*City of El Paso – City Plan Commission Staff Report*

**Case No:** SUSU12-00015 Enchanted Hills Unit Three  
**Application Type:** Major Combination  
**CPC Hearing Date:** March 8, 2012  
**Staff Planner:** Kevin Smith, 915-541-4903, [smithkw@elpasotexas.gov](mailto:smithkw@elpasotexas.gov)  
**Location:** North of Transmountain Road and East of I-10  
**Legal Description Acreage:** 97.03 acres  
**Rep District:** 1  
**Existing Use:** Vacant  
**Existing Zoning:** R-5/sp  
**Proposed Zoning:** N/A

### ATTACHMENT 3

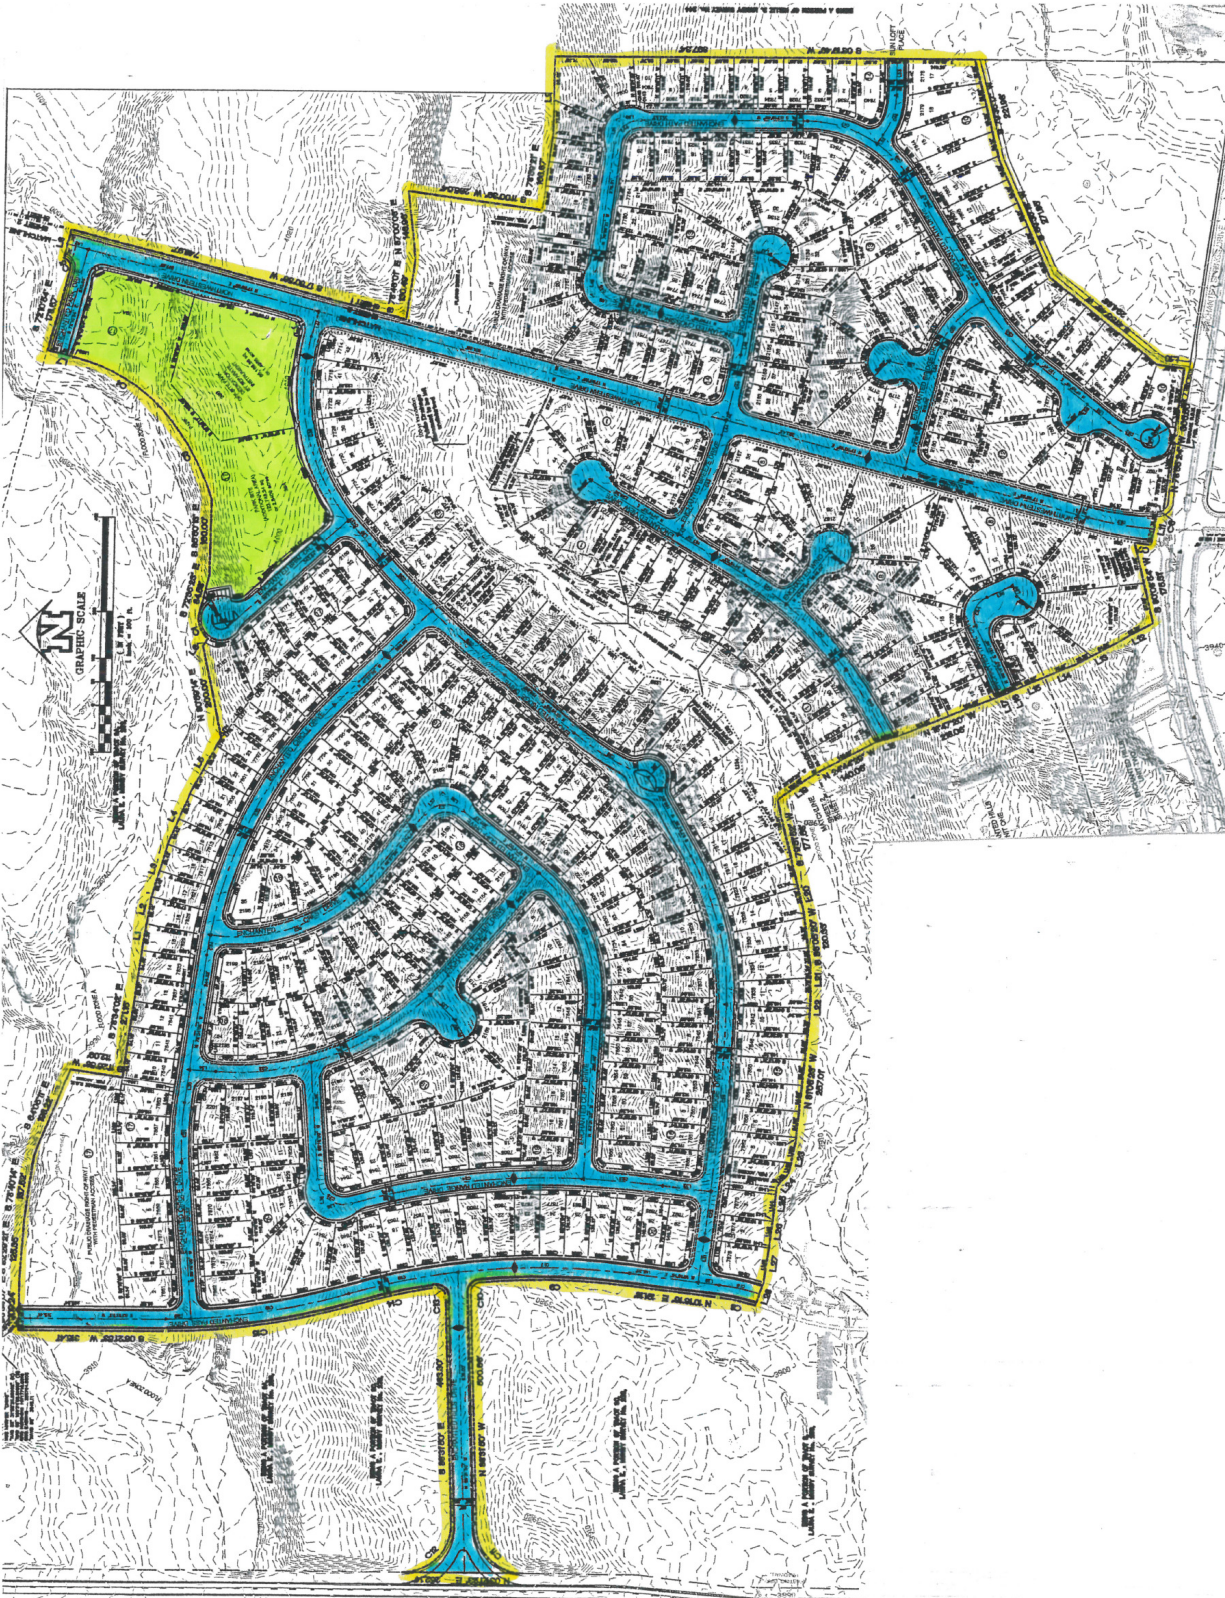
1. Dedicate Lot 18 of Block 24 and Lot 1 of Block 17 as Drainage Right-of-way/with Pedestrian Access only. If these lots are to be dedicated as ponds, they must meet the City of El Paso Design Standards for Construction's Detention Basin Design Requirements, which requires an overflow spillway.

2. The proposed subdivision is located near a potential sediment flow source. At the improvement plan stage EPWU requires the Engineer to account for sediment volume in all calculations used to size stormwater drainage structures. Provide appropriate stormwater infrastructure to prevent sediment from clogging the proposed crossings on Enchanted Pass Drive and Northwestern Drive.

3. During design of the subdivision improvements ensure water crossings on Northwestern Drive and Enchanted Pass Drive are large enough to convey stormwater runoff and sediment from the upstream areas. Provide sufficient access for EPWU Stormwater Utility mechanized maintenance equipment and vehicles. EPWU prefers bridge crossings or 6-foot high concrete box culverts.

5. At the improvement plan stage provide additional erosion/scour protection for proposed retaining walls abutting Flow Path 42B and Flow Path 42C. Consider using gabion retaining walls along the Flow Paths.
